TO : All Bidders
FROM : James P. DiCamillo
PROJECT : Rowland High School Additions/Renovations
Project 1310700.41
SUBJECT : Addendum 1
DSA : 03-115771 / 19-H54

The following changes, omissions, and/or additions to the Project Manual and/or Drawings shall apply to proposals made for and to the execution of the various parts of the work affected thereby, and all other conditions shall remain the same.

DRAWING NUMBER: **AA3.1**

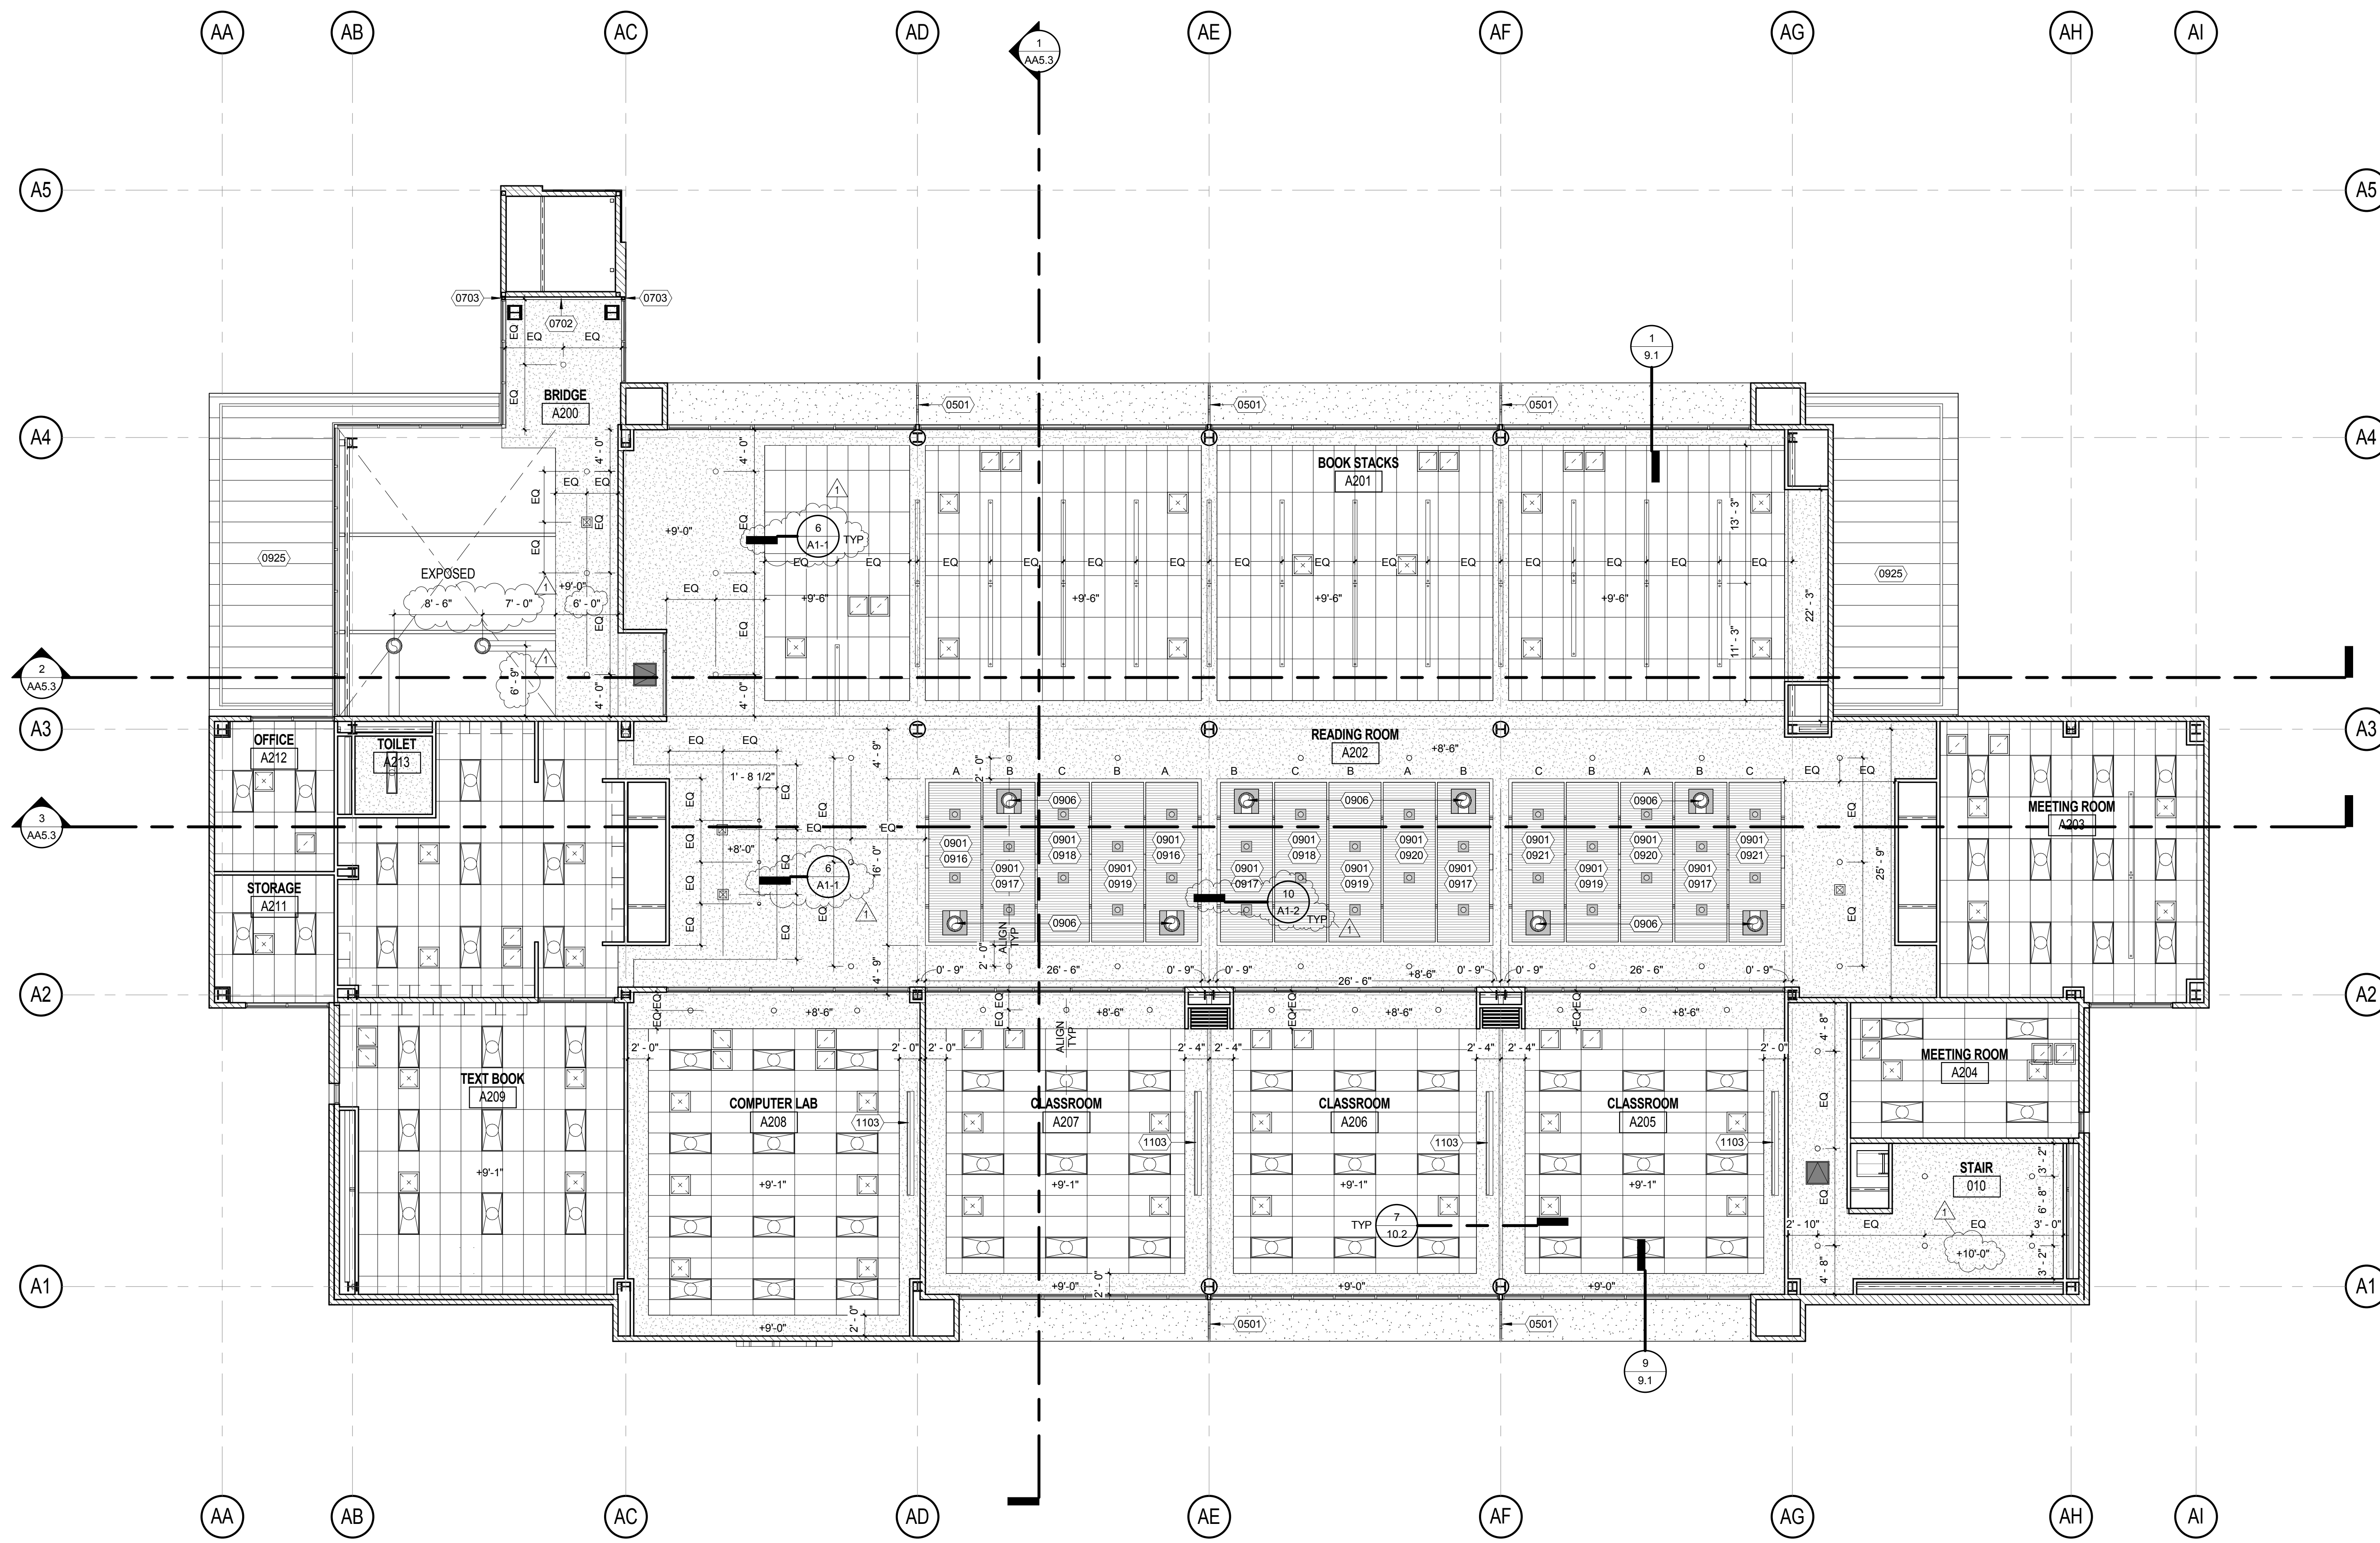
- 1.6 DRAWING AA3.1 - ADMINISTRATION/LIBRARY BUILDING A FIRST FLOOR REFLECTED CEILING PLAN
- A. Replace drawing with the revised Drawing AA3.1 marked with Delta 1 attached.

DRAWING NUMBER: **C2.01**

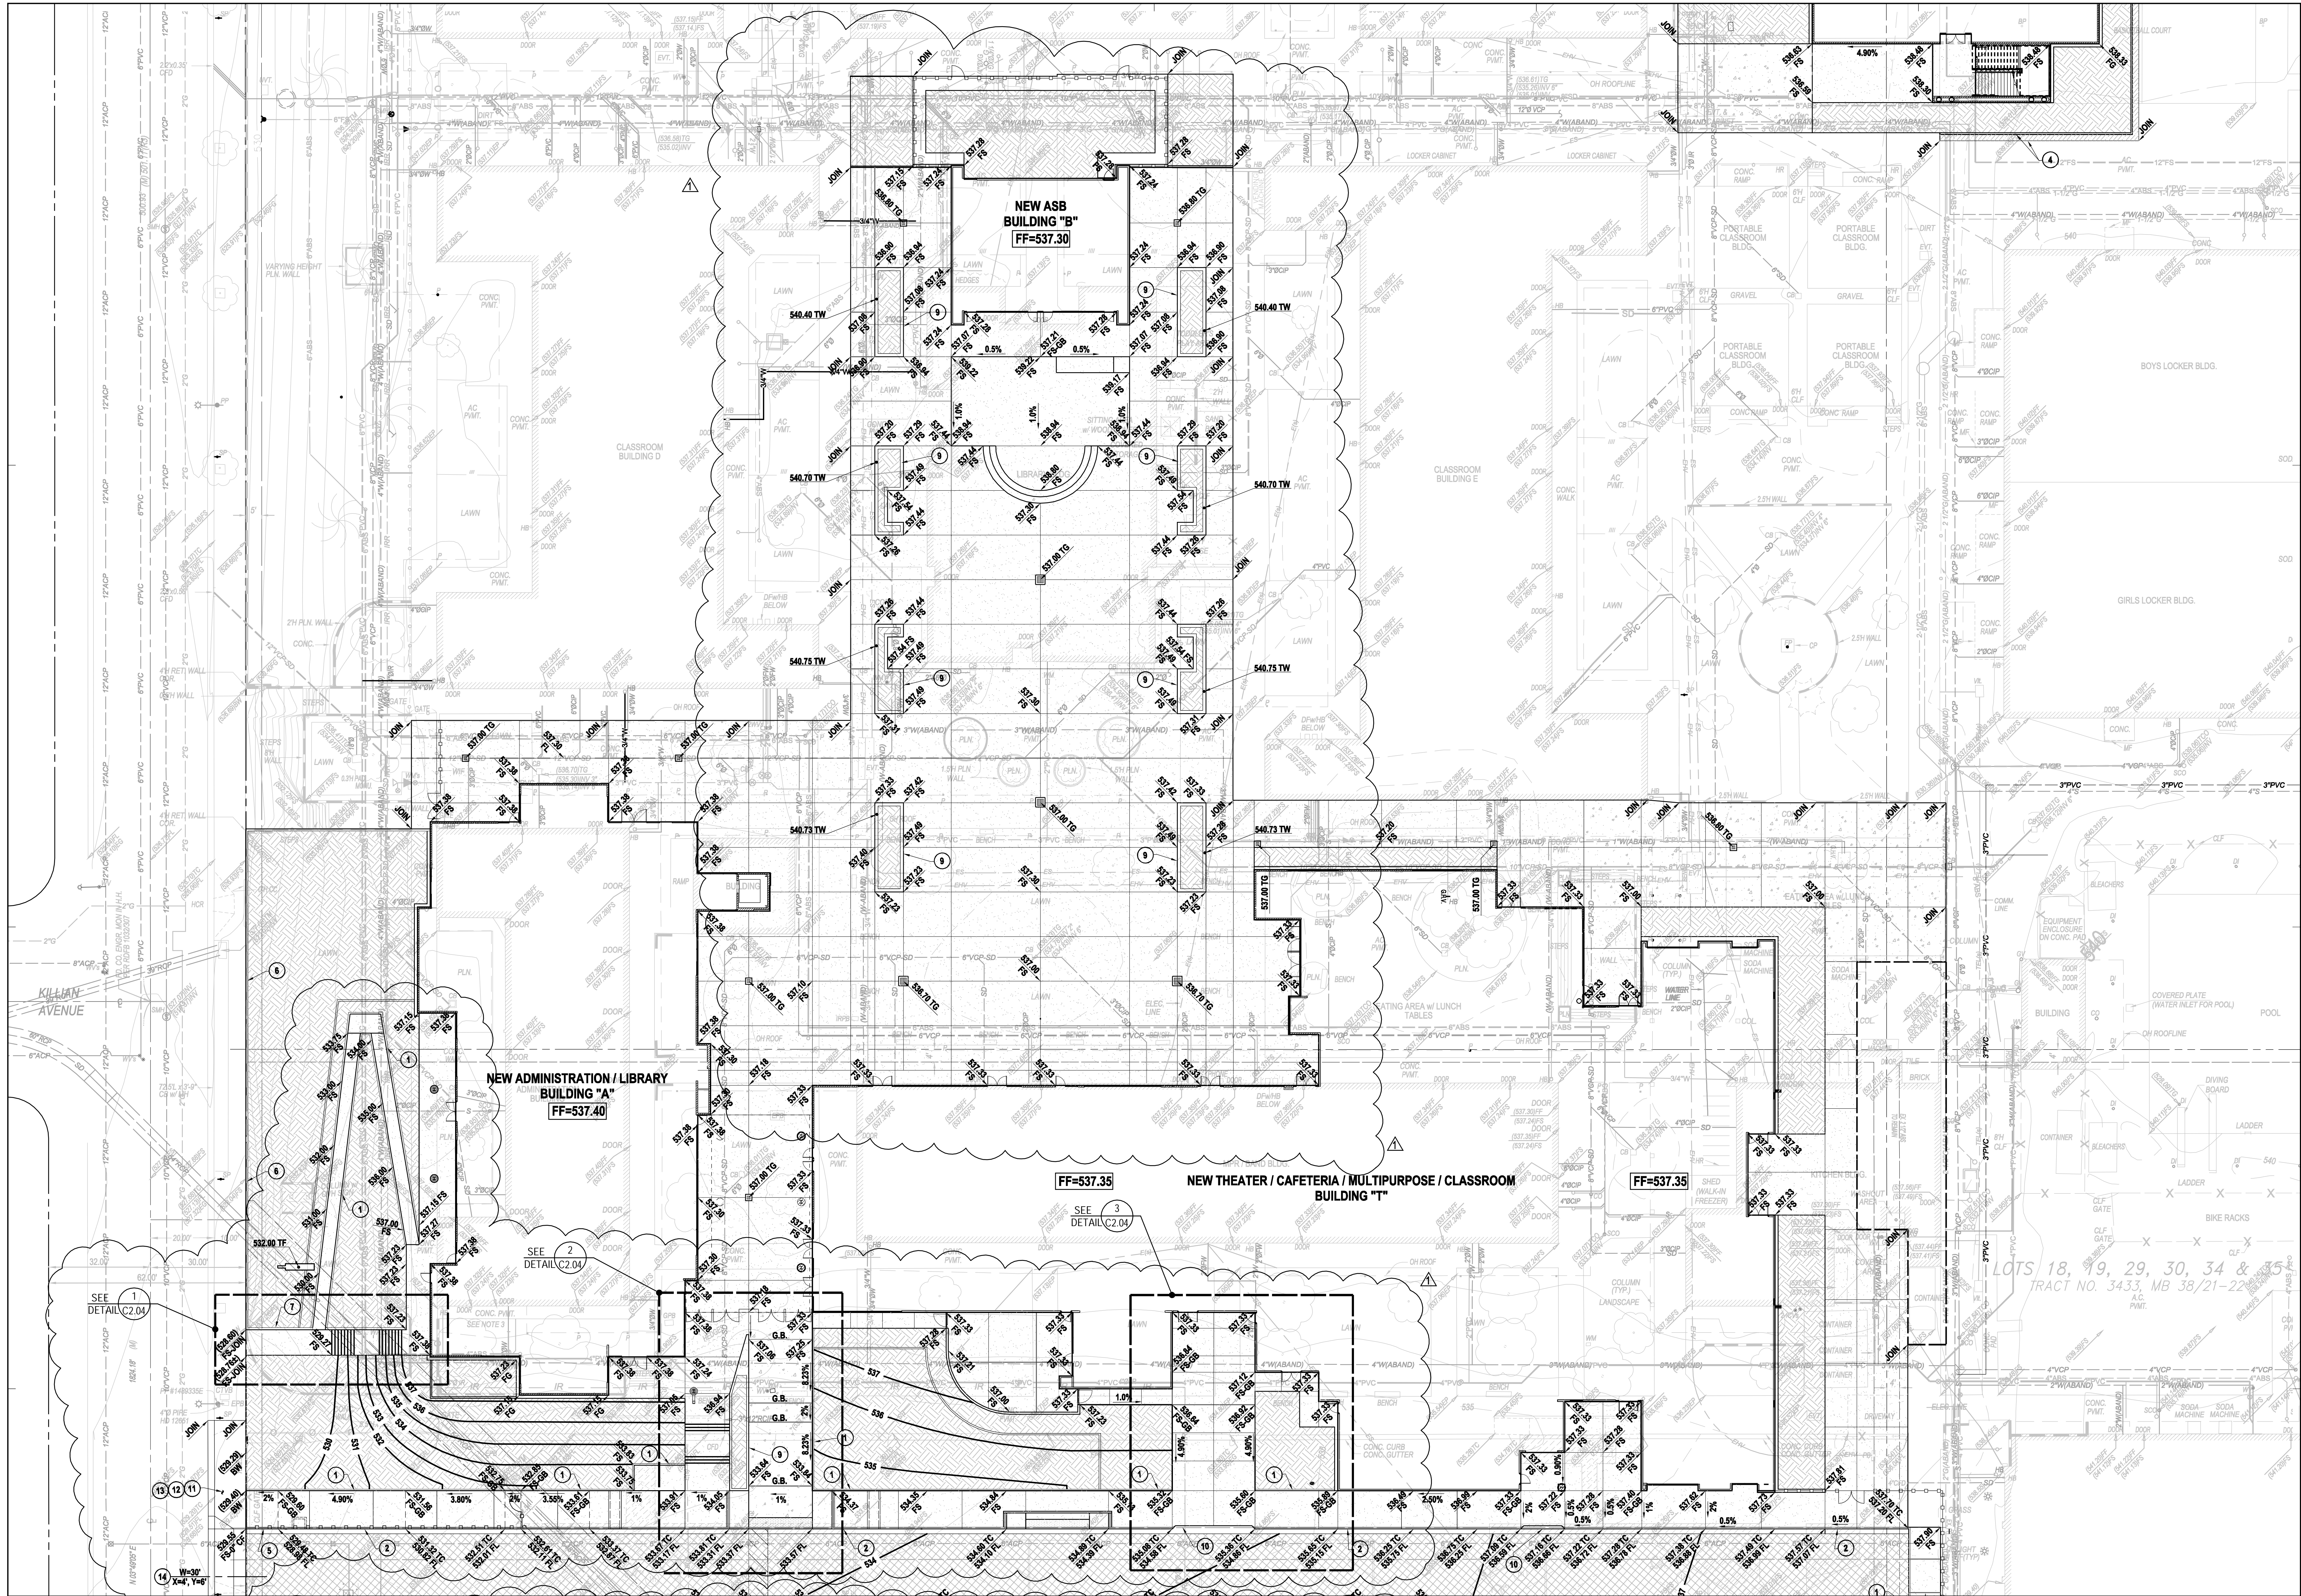
- 1.61 Replace the following Civil drawings with the attached revised drawings marked with Delta 1.
- A. C0.02 - Abbreviations, Legends and Notes.
 - B. C2.01 - Precise Grading Plan.
 - C. C2.02 - Precise Grading Plan.
 - D. C2.03 - Precise Grading Plan.
 - E. C2.04 - Ramp and Stair Details.
 - F. C3.01 - Storm Drain Plan.
 - G. C3.02 - Storm Drain Plan.
 - H. C3.03 - Storm Drain Plan.
 - I. C4.01 - Utility Plan.
 - J. C4.02 - Utility Plan.
 - K. C4.03 - Utility Plan.
 - L. C5.01 - Improvement Details.
 - M. C5.04 - Utility Details.

DRAWING NUMBER: **S1.6**

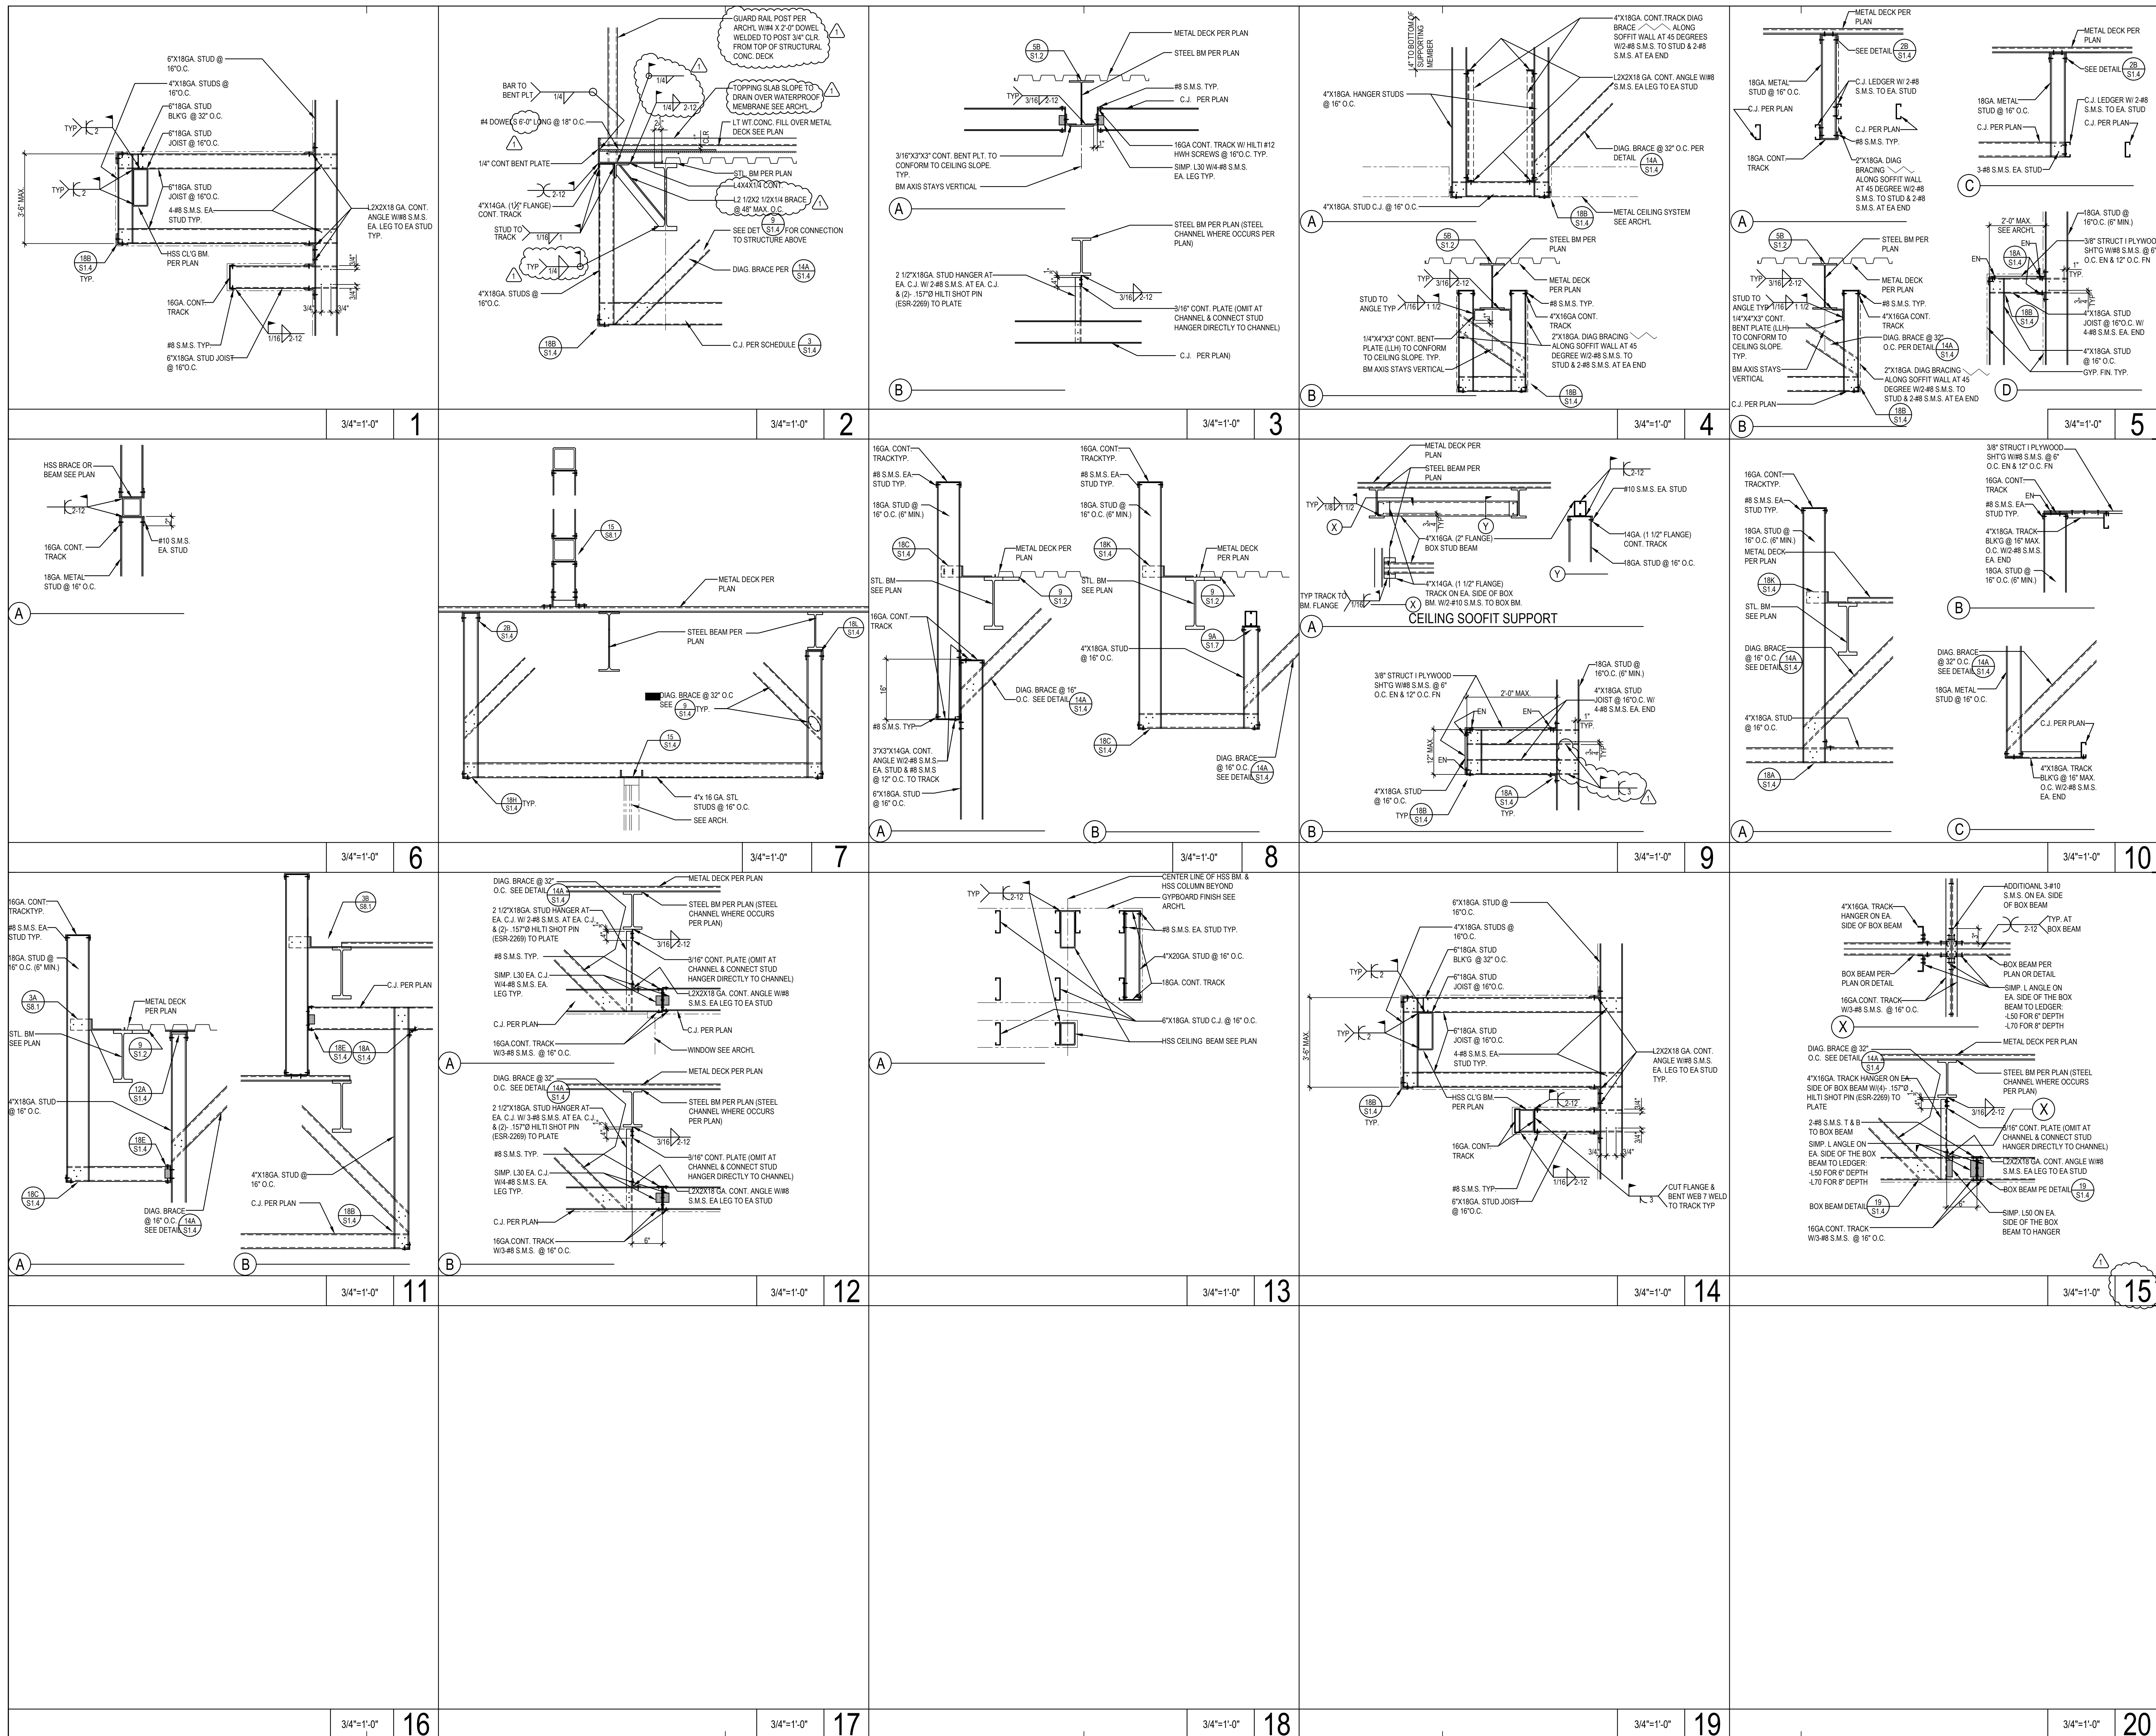
- C. S1.6 - Site Plans and Details.
- D. S1.7 - Typical Details.
- E. S7.1 - Details.
- F. S7.2 - Details.
- G. S8.1 - Details.
- H. S8.2 - Details.
- I. S8.3 - Details.
